# UNITED STATES PATENT AND TRADEMARK OFFICE

## Office Action Summary

10/632,273

FARNWORTH ET AL.

**Selected Portion of Figure 4**

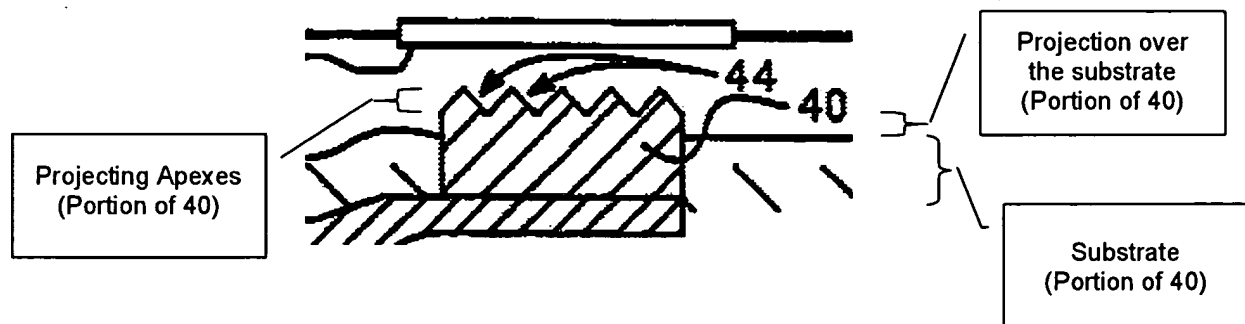
Agahdel et al anticipates (Figure 4) an engagement probe (40) comprising:

A substrate (that portion of 40 as labeled below);

A projection supported over the substrate (that portion of 40 as labeled below) and comprising material of the substrate; and

A grouping of a plurality of projecting apexes (that portion of 40 as labeled below) extending from the projection and positioned in sufficient proximity to one another to collectively engage a single conductive pad (45) on a semiconductor substrate (22); as recited in claim 31.

As to claim 33 the added limitation of the apices being in the shape of multiple knife-edge lines is anticipated (because Figure 4 is a cross-sectional view of Figure 3 along line 4--4, the "Projecting Apexes" are part of a 3-dimensional object having each cross-sectional component, or slice, as a "Projecting Apex." Thus the tips of all the slices in combination form a knife-edge line; see also col 6, ln 16-29).

As to claim 45, the added limitation of the plurality of projecting apexes extending from a substantially planar uppermost surface (note base of Projecting Apexes are linear to each other and therefore form a plane along line 4--4 of Figure 3) of the projection is anticipated.
